SUBJECT: Solid Waste Permit No. 26-08, Permit to Construct: Revise C & D Landfill Phase I, Fort Bragg C & D Facility, Fort Bragg, Cumberland County

SUBJECT: Solid Waste Permit No. 26-08
PERMIT TO CONSTRUCT: Revise C&D Landfill PHASE I
Fort Bragg C&D Facility; Fort Bragg, Cumberland County

LAND CLEARING AND INERT DEBRIS AND CONSTRUCTION AND DEMOLITION LANDFILL

FACILITY PLAN

PHASE I SUBGRADE

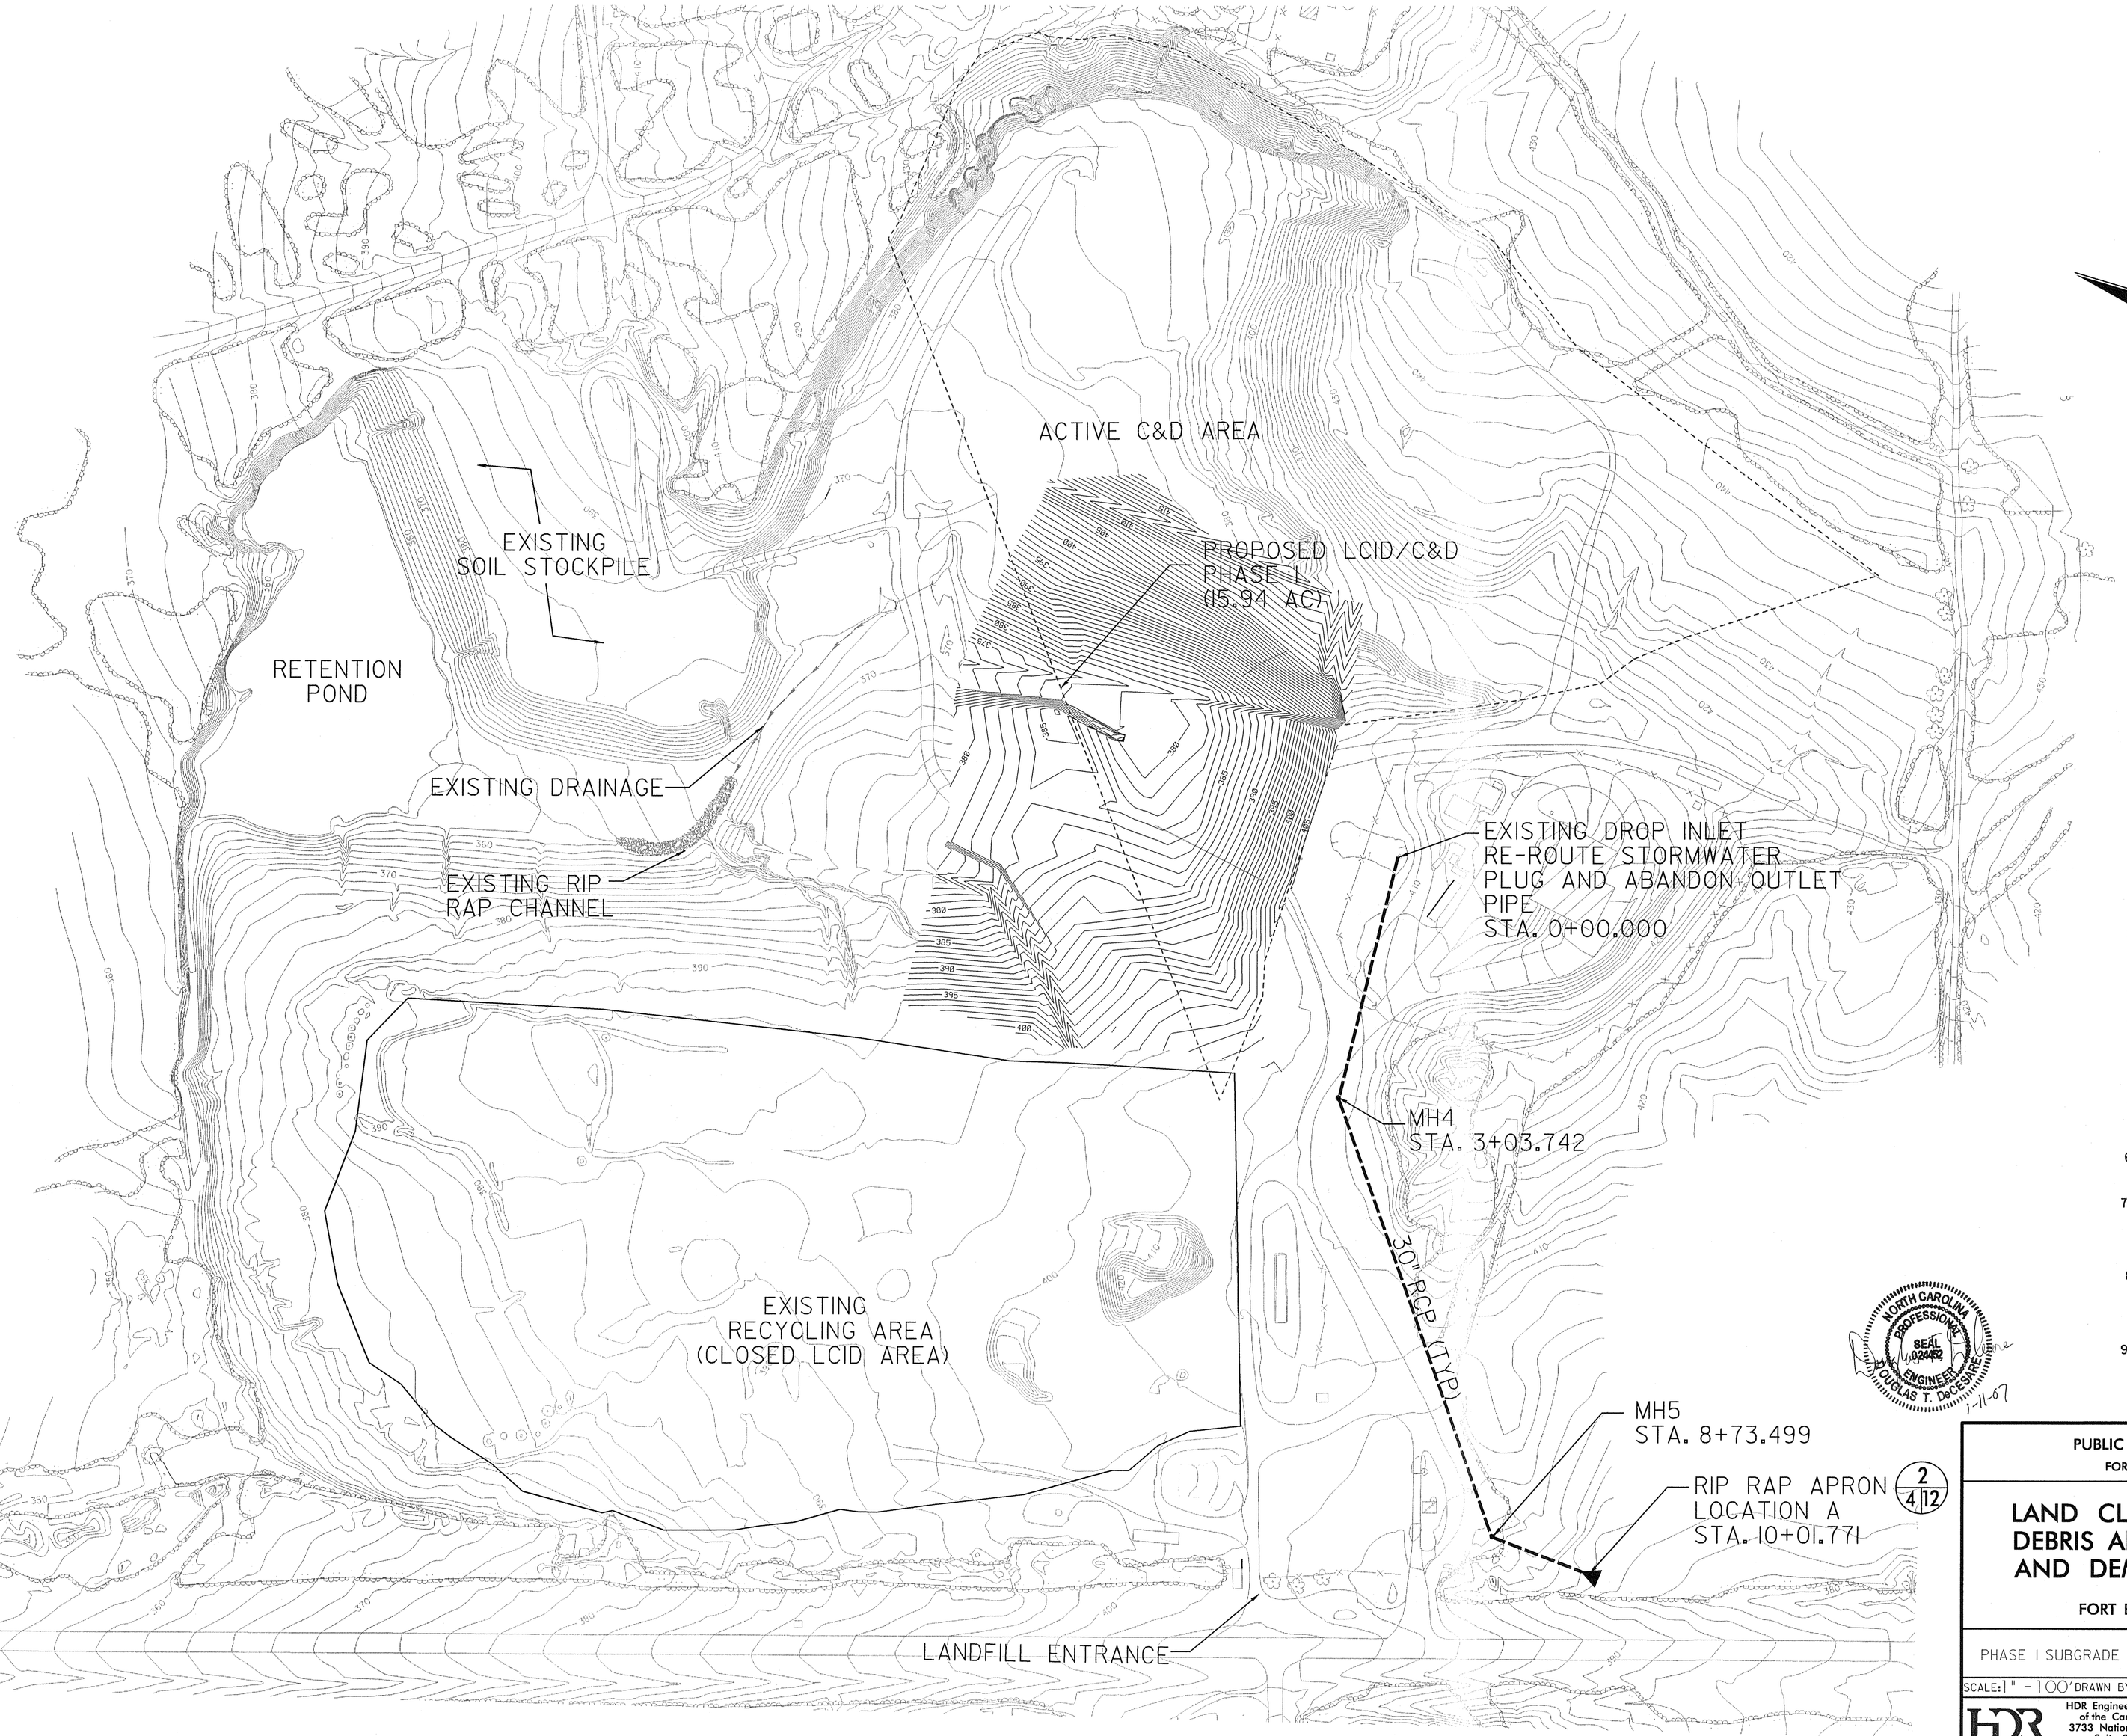
1. EXISTING TOPOGRAPHY SUPPLIED BY THE ROSE GROUP FROM AND AERIAL PHOTOGRAPH DATED NOVEMBER 17, 2003.
2. COORDINATE SYSTEM IS NC STATE PLANE, NAD 83.
3. EXCAVATED VOLUME: 39,000 CY.
4. ANY SURPLUS OF SOIL EXCAVATED NOT USED IN OPERATIONS WILL BE STOCKPILED IN THE EXISTING STOCKPILE LOCATION.
5. EXISTING STORMWATER FEATURES SHALL BE UTILIZED AND MAINTAINED DURING OPERATIONS WITHIN PHASE I.
6. RECYCLING AREA SHALL BE PLACED OVER THE LCID CAP SYSTEM.
7. WASTE ENCOUNTERED DURING INSTALLATION OF STORMWATER PIPING WILL BE WEIGHED AND HAULED TO THE ACTIVE FILL AREA.
8. A PORTION OF THE PHASE I TOPOGRAPHY WAS PREPARED BY TMS CONTRACTING, LLC DATED OCTOBER 2006.
9. PHASE I LIMITS OF WASTE INCREASED 0.24 ACRES.

PHASE I FINAL GRADE PLAN

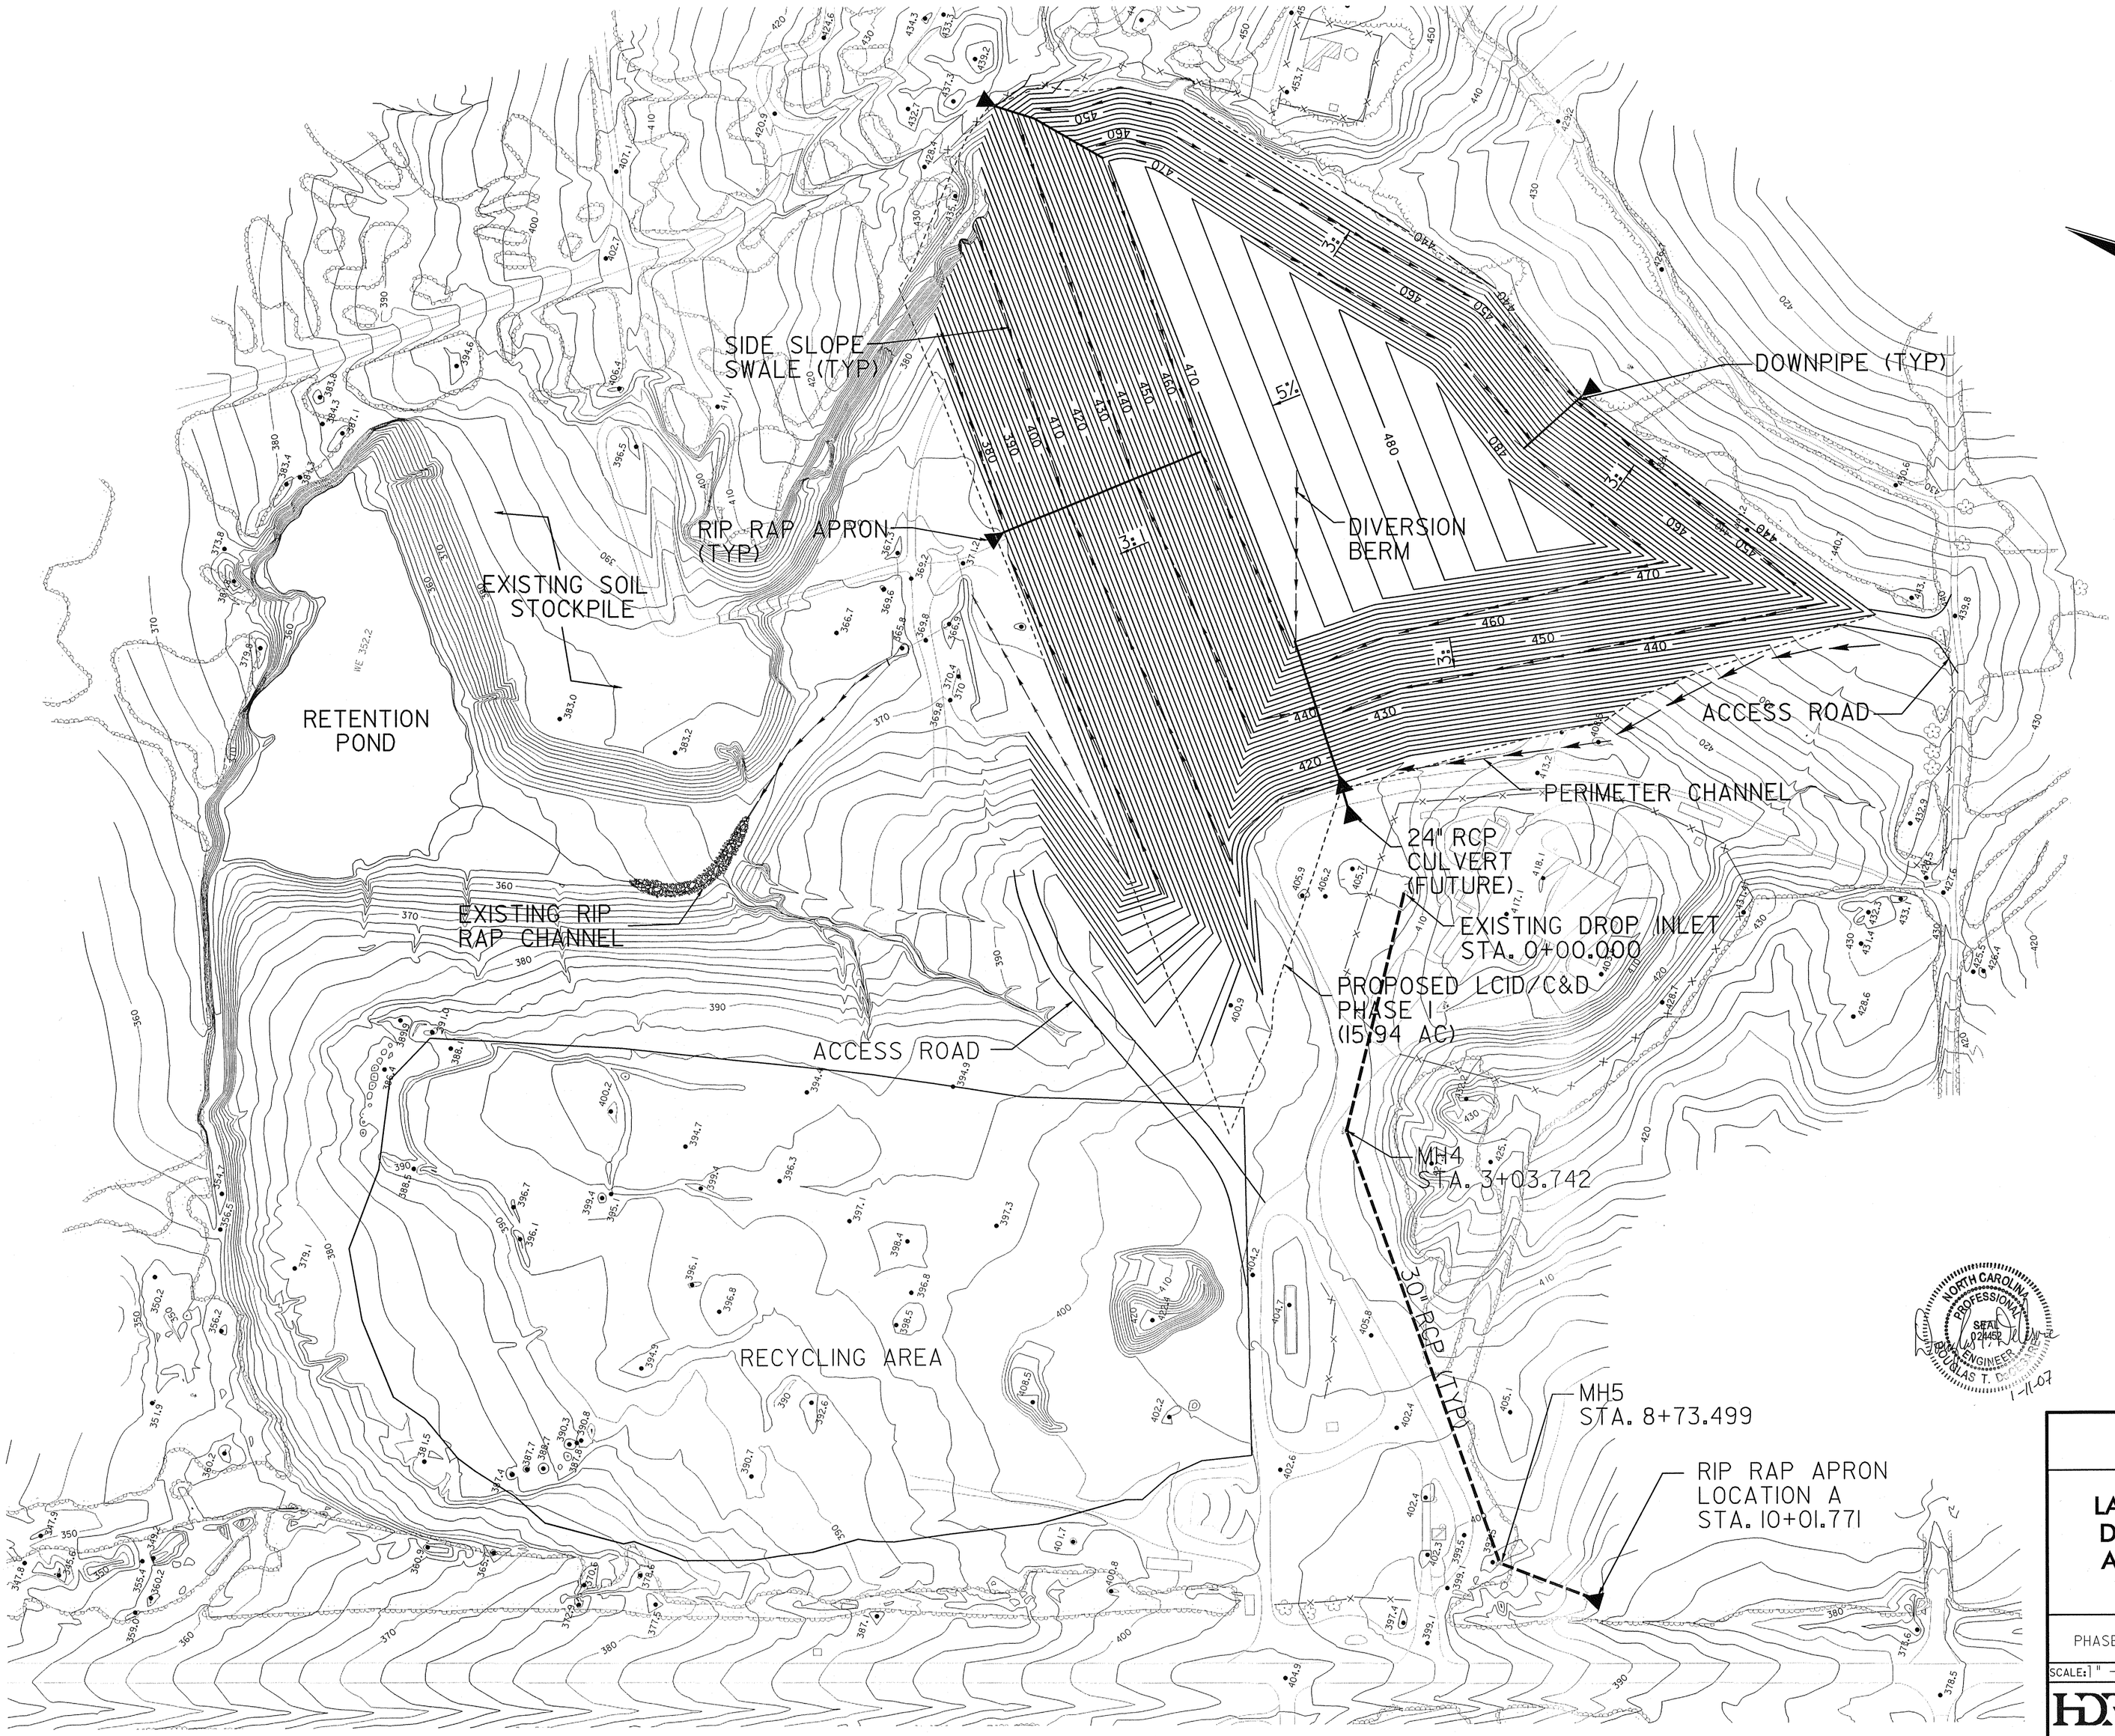
1. EXISTING TOPOGRAPHY SUPPLIED BY THE ROSE GROUP FROM AN AERIAL PHOTOGRAPH DATED JULY 12, 2003.
2. COORDINATE SYSTEM IS NC STATE PLANE, NAD 83.
3. DIVERSION BERMS ARE PROPOSED TO CONTROL STORMWATER FLOW.
4. A PORTION OF THE PHASE I TOPOGOGRAPHY WAS PREPARED BY TMS CONTRACTING, LLC DATED OCTOBER 2006.
5. PHASE I LIMITS OF WASTE INCREASED 0.24 ACRES.

REV. NOTE = AN ADDITIONAL 13,000 CY IN AIRSPACE WAS GAINED DUE TO REVISED CONSTRUCTED BASEGRADES.
